CENTERVILLE CITY PLANNING COMMISSION AGENDA

Short Title: ADMINISTRATIVE DECISION - Public Hearing - Conceptual Site & Conceptual Subdivision Plans- Canyon Point

**PLANNING STAFF REPORT
AGENDA ITEM: 1**

APPLICATIONS: CONCEPTUAL SITE PLAN REVIEW WITH
CONCEPTUAL SUBDIVISION ACCEPTANCE

CANYON POINT IN CENTERVILLE PLANNED UNIT DEVELOPMENT

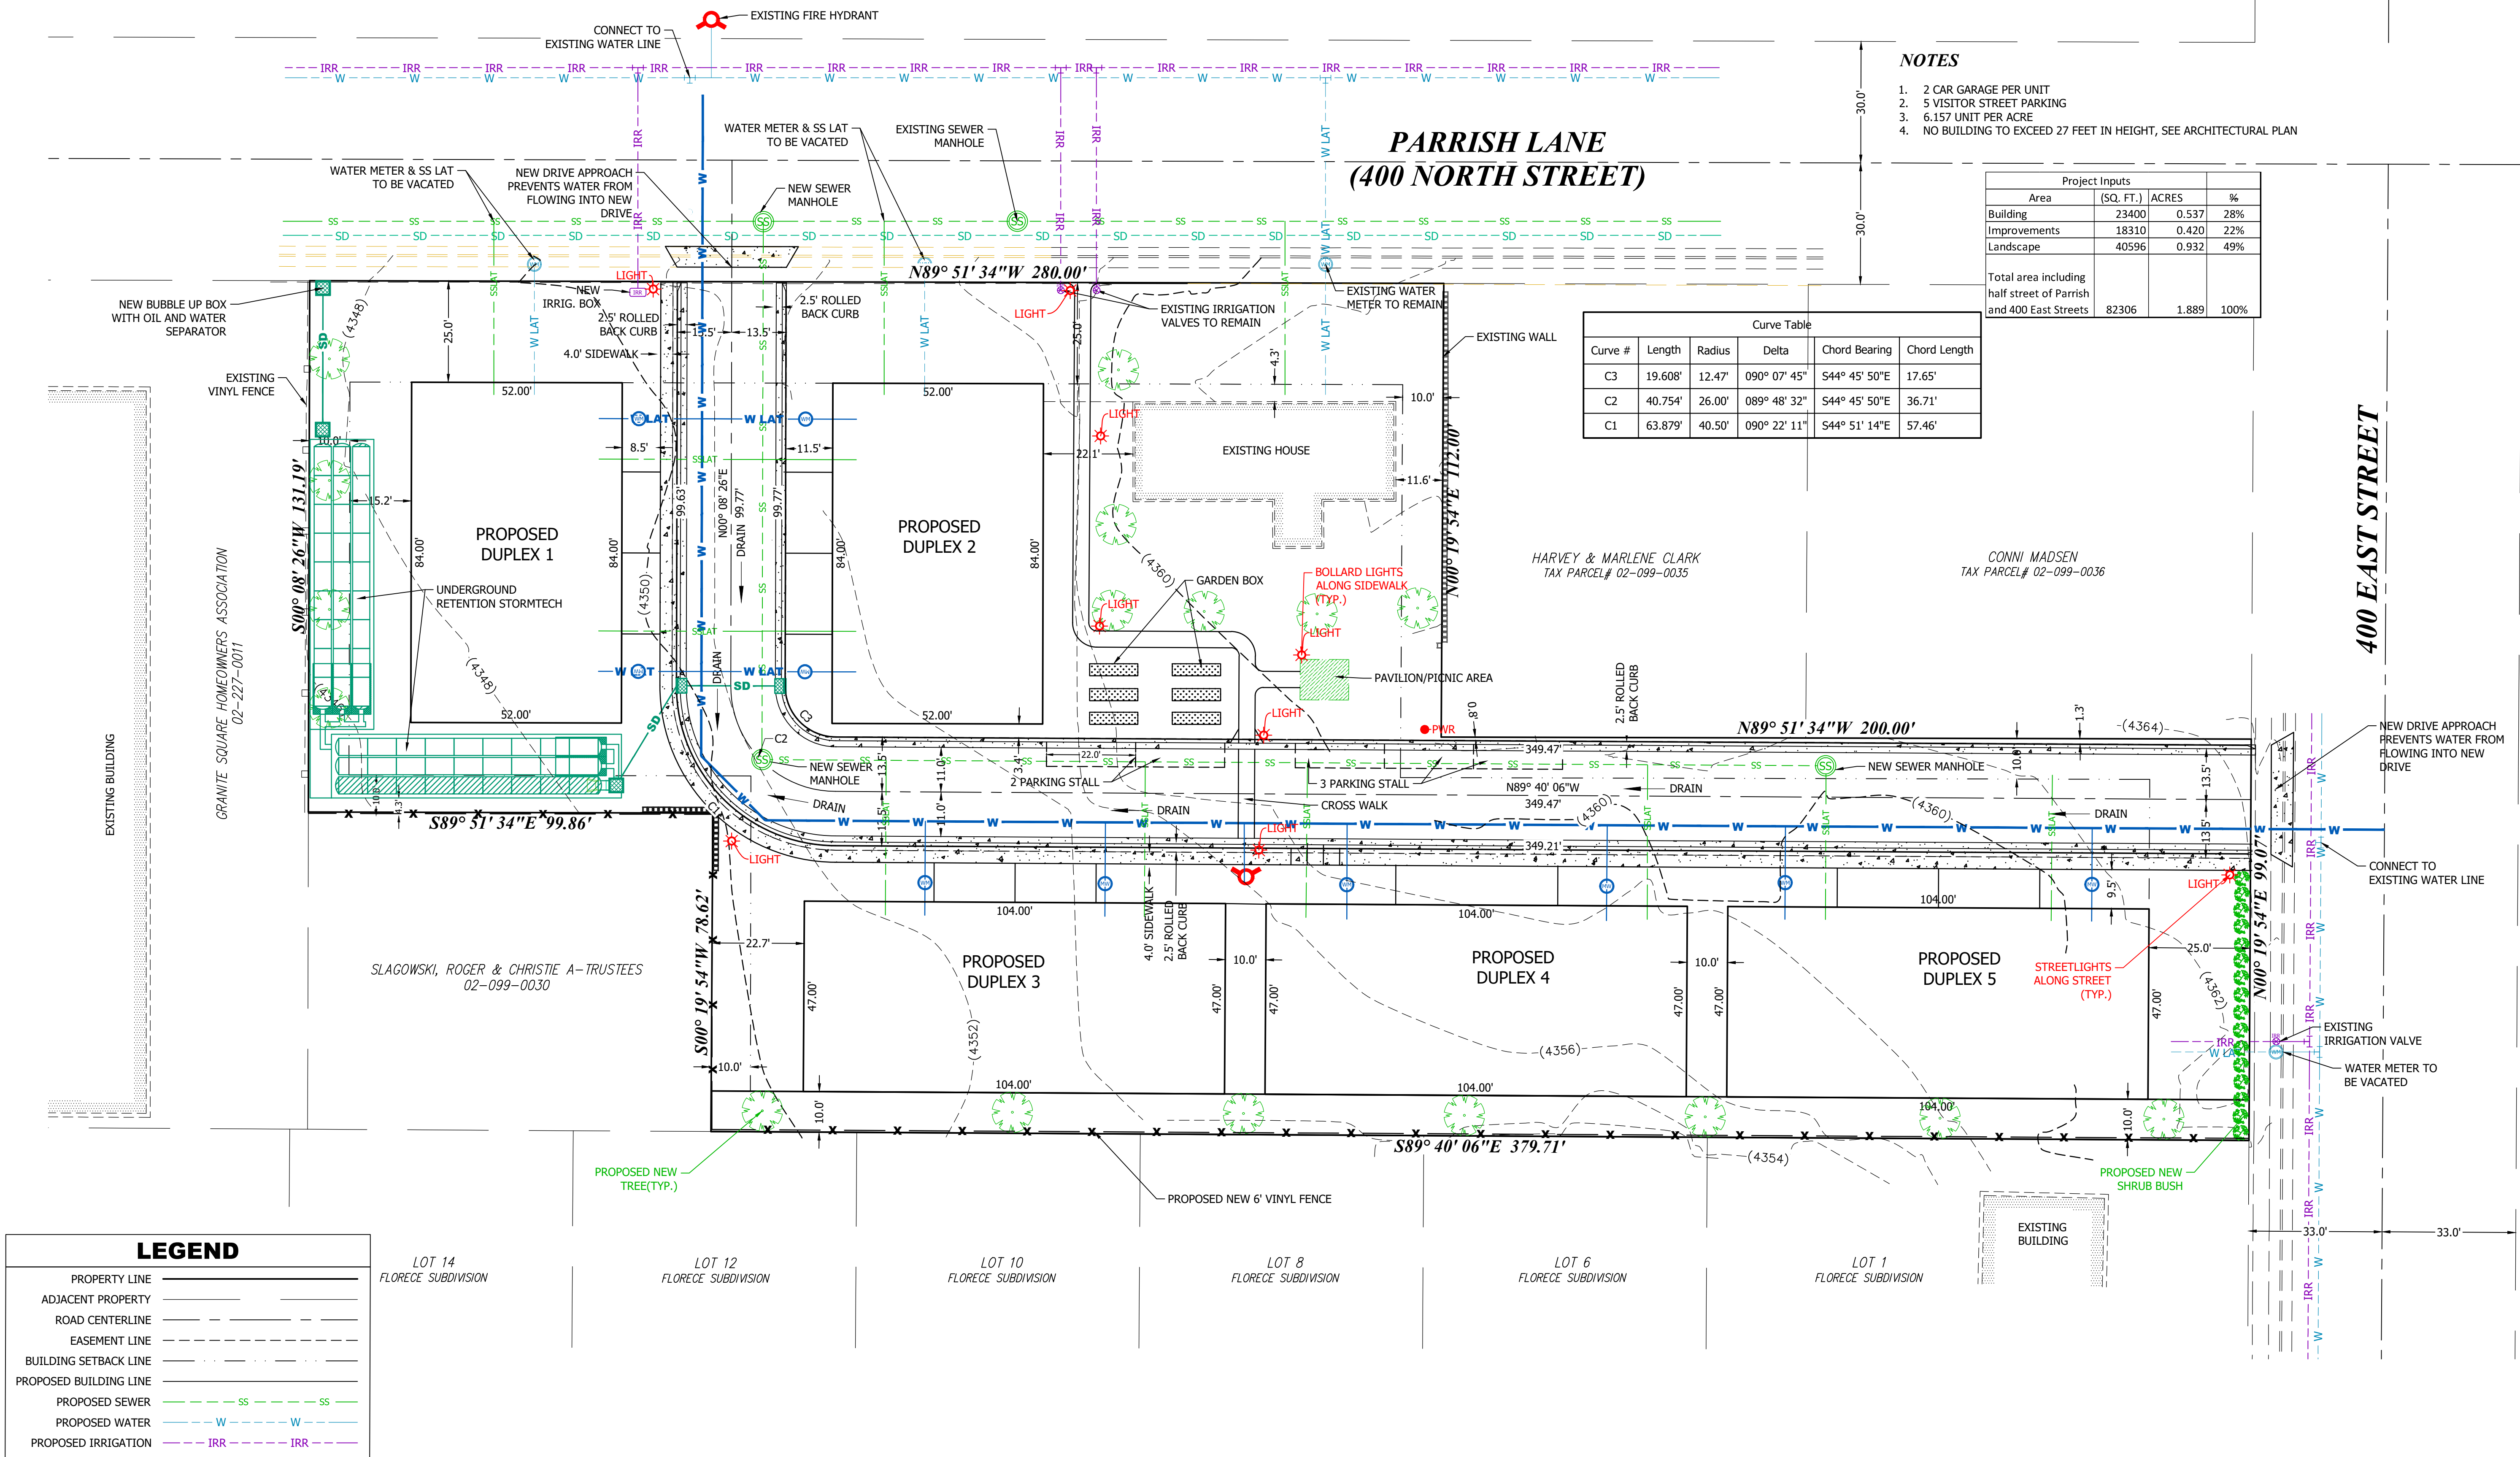
Staff Comments - The final site plan layout needs to ensure there is enough room for cars to exit the garages while cars are parked on the street.

Staff Comments - The plans do not show any detail concerning the trash enclosures or other means of service.

- Entrance Radii need to be minimum of 25' with subdivision style entrance (not a single-family drive approach entrance). The new entrances will need to be similar to The Hive Subdivision, Sheffield Subdivision, and other recently approved Subdivisions.*
- An inlet box needs to be added at 400 East such that drainage from 400 East does not enter the new private road.*
- A report showing the soil infiltration rates and retention volume calculations will need to be submitted.*
- The retention basin must outflow / bubble up on the City street, not back of sidewalk.*
- Show new pressurized irrigation system main line through private street with service to each lot.*
- Show nearest fire hydrant on 400 East Street.*

1. Entrance Radii need to be minimum of 25' with subdivision style entrance (not a single family drive approach entrance). The new entrances will need to be similar to The Hive Subd, Sheffield Subd and other recently approved Subdivisions.
2. An inlet box needs to be added at 400 East such that drainage from 400 East does not enter the new private road.
3. A report showing the soil infiltration rates and retention volume calculations will need to be submitted.
4. The retention basin must outflow / bubble up on the City street, not back of sidewalk.
5. Show new pressurized irrigation system main line through private street with service to each lot.
6. Show nearest fire hydrant on 400 East street.

1. *A final site plan shall be submitted as outlined in Section 12.21.110(e) of the City's Zoning Ordinance.*
2. *The site layout shall be corrected to meet the setback requirements, or the applicant may use CZC 12.55.130(1), to enhance the internal development layout spacing.*

3. *The site plan layout shall be corrected to provide the required six (6) visitor parking stalls and correct fence heights within any front yard area.*

5. *The Final Site Plan submittal shall address the trash enclosures or other means of refuse service.*
6. *If the applicant desires to have signage for the project, this shall be indicated on the final site plan and meet the requirements found in Chapter 12.54 of the Zoning Ordinance*

7. *As part of the Final Site Plan Submittal, the applicant shall obtain and submit all missing and applicable utility provider comment sheets.*
8. *The Final Site Plan and/or Preliminary Subdivision submittal shall address the City Engineer's comments regarding the development's civil engineering. Additionally, a soils study shall be prepared to determine the depth of the water table.*

Site Plan

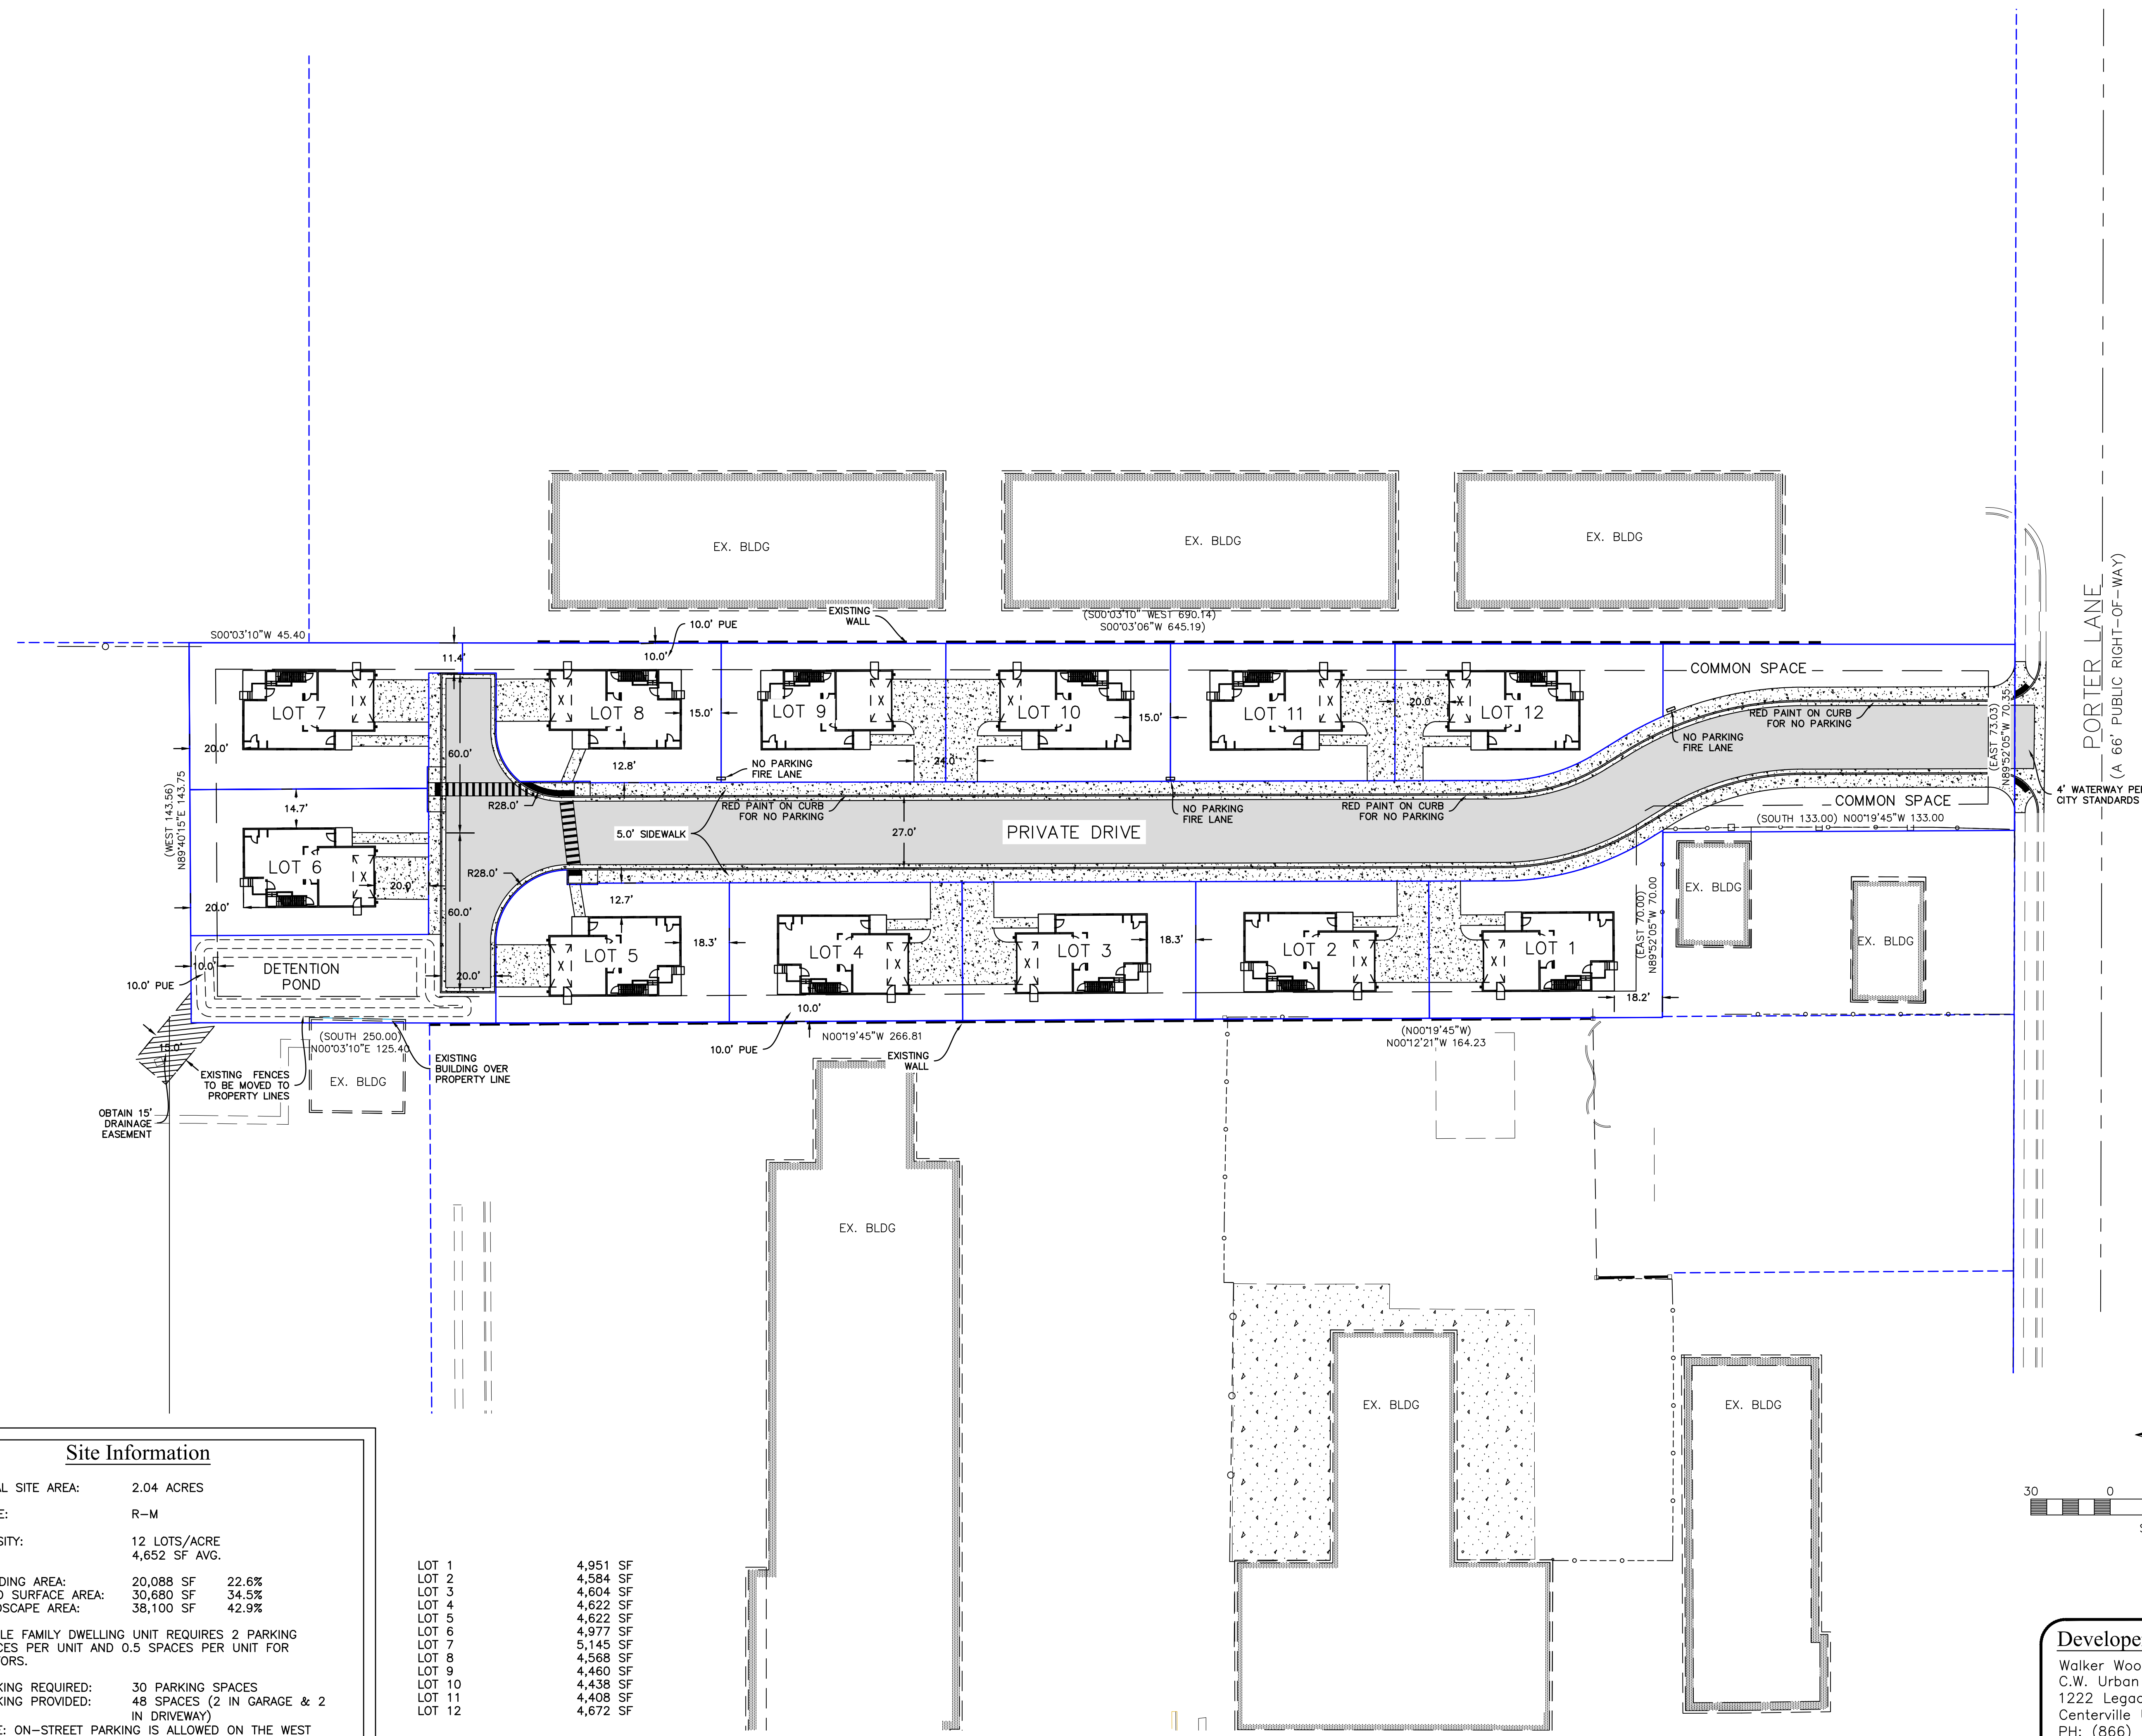
Staff Response: The subdivision will be accessed by a 27-foot wide private lane. There is only one point of ingress and egress, with a hammerhead turn around to comply with Fire Code regulations. There are five-foot wide sidewalks on both sides of the street, and the eastern curb will be a no parking zone. Fifteen on-street parking spaces will be available on the western side of the private lane, meeting

Staff Response: Subdivision style entry signs have not been depicted.

In addition, City-approved streetlights ‘shall be provided at all street intersections’ and every 500 feet. The submittal does not show streetlights.

1. A Final Site Plan shall be submitted as outlined in CZC 12.21.110(e).
2. Provide stamped architectural plans at Final Site Plan application.
3. If the applicant desires to have signage for the project, this shall be indicated on the Final Site Plan and meet the requirements found CZC 12.54.

1. A Preliminary Subdivision Application shall be prepared in accordance with CMC 15.03.030.
2. The applicant shall obtain Final Site Plan Approval prior to or in conjunction with a Preliminary Subdivision submittal to ensure that the Site's development layout is finalized.
3. The applicant shall provide street light information at Preliminary Submittal.
4. The applicant shall provide proof of drainage compliant with applicable City Ordinance.
